Application Reference PL/2023/06402 – Subdivision of the residential plot and the erection of a dwelling to the southwest of '150 Bouverie Avenue South', together with hard and soft landscaping and associated works.

This document is submitted following examination of the above referenced application, detailing objections raised to the scheme as proposed and the numerous factual inaccuracies within the planning statement.

Figure 1 – side by side comparison of proposed elevations PL/2021/05643 (left) and PL/2023/06402 (right)

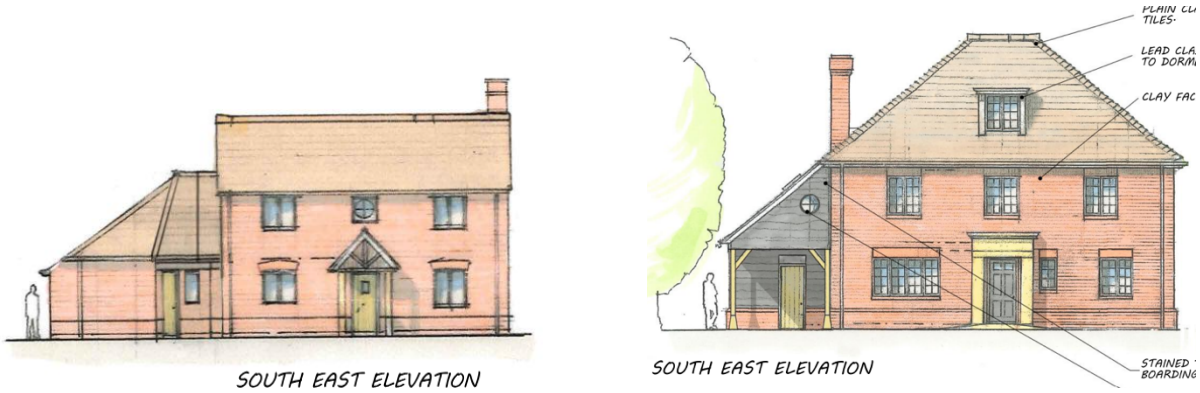
The Planning Statement claims at Para 4.15: "The scale, design and massing of the proposal are very similar to those considered acceptable within the outline application (PL/2021/05643)."

The submitted and approved outline plans and elevations dated 28 Sep 21 show a two storey, four-bedroom, three-bathroom house. At the time, numerous neighbours and Salisbury City Council objected to these due to overdevelopment. The recent submission dated 31 Jul 23 shows a five-bedroom, six-bathroom house. The primary objection is that this differs so vastly from the original outline submission that the planning application should be considered as a new application and refused in its entirety.

Figure 7 – Annotated proposed site plan

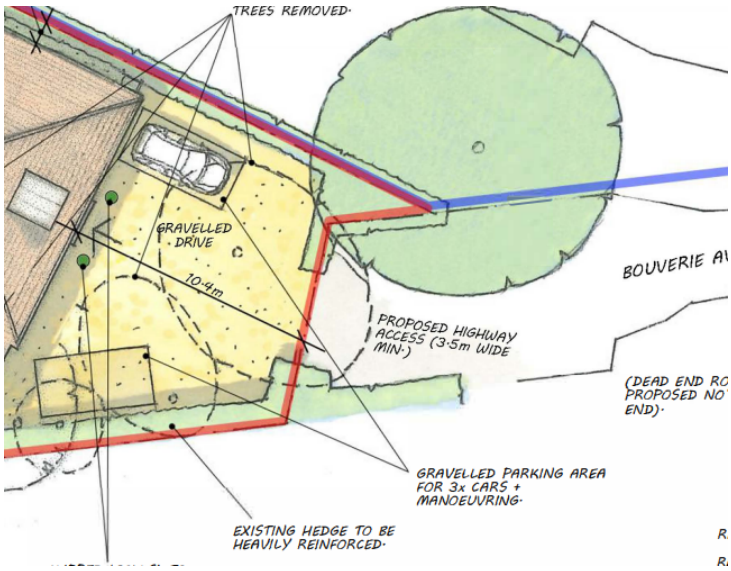
Partially to account for potential development at 150 BAS, we have gained approval (PL/2023/03531) to move our garage to the north west corner of our garden which will enable us to create more usable parking within our curtilage. In response to an objection made by Atlas Planning and 150 BAS, the outer hedge to the north of the garage must remain as a condition of the planning. This hedging is shown in in Figure 7 as the hedge outside the proposed development boundary to the south. The planning statement also indicates that this hedging will form part of their entranceway, with a stub extending northwards at the southern part of the entranceway, but any hedging for this purpose must be within their boundary and not outside as depicted in Figure 7.

The submitted proposed site plan shows the proposed highway access in a central position at the end of the roadway. This could cause potential safety issues with the proximity to our driveway at 161 BAS, particularly with the view obscured by hedging. By putting the entrance in the centre of the road will result in a **detrimental impact to highway safety** as cars accessing 161 BAS may interact with those accessing the proposed new driveway. The proximity of the entrance driveways coupled with a limited sight line is nothing short of dangerous. The recommendation is to bias the entrance driveway as far to the north as possible to reduce the significant safety impact.

Figure 8 – Approved site plan PL/2023/03531

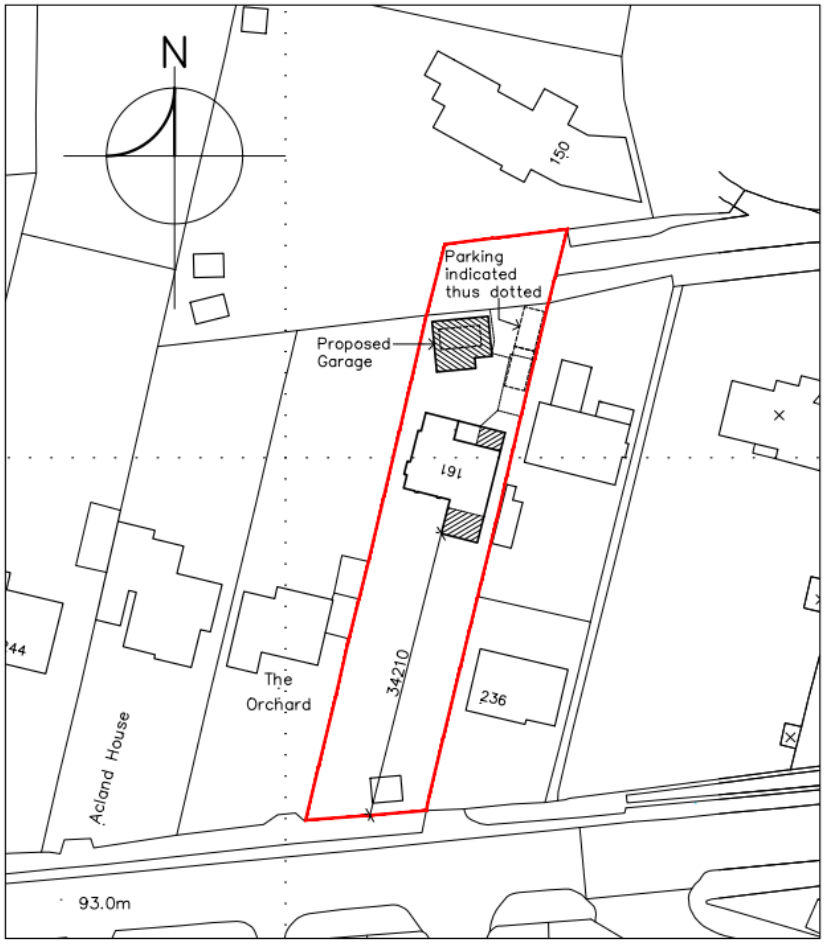
The end of the road is not designated turning area. It forms part of 161 BAS (see figure 8) over which 150 BAS have a right of access only. All other houses on this stretch of BAS have driveways perpendicular to the private road, this allows turning into or out of their driveways.
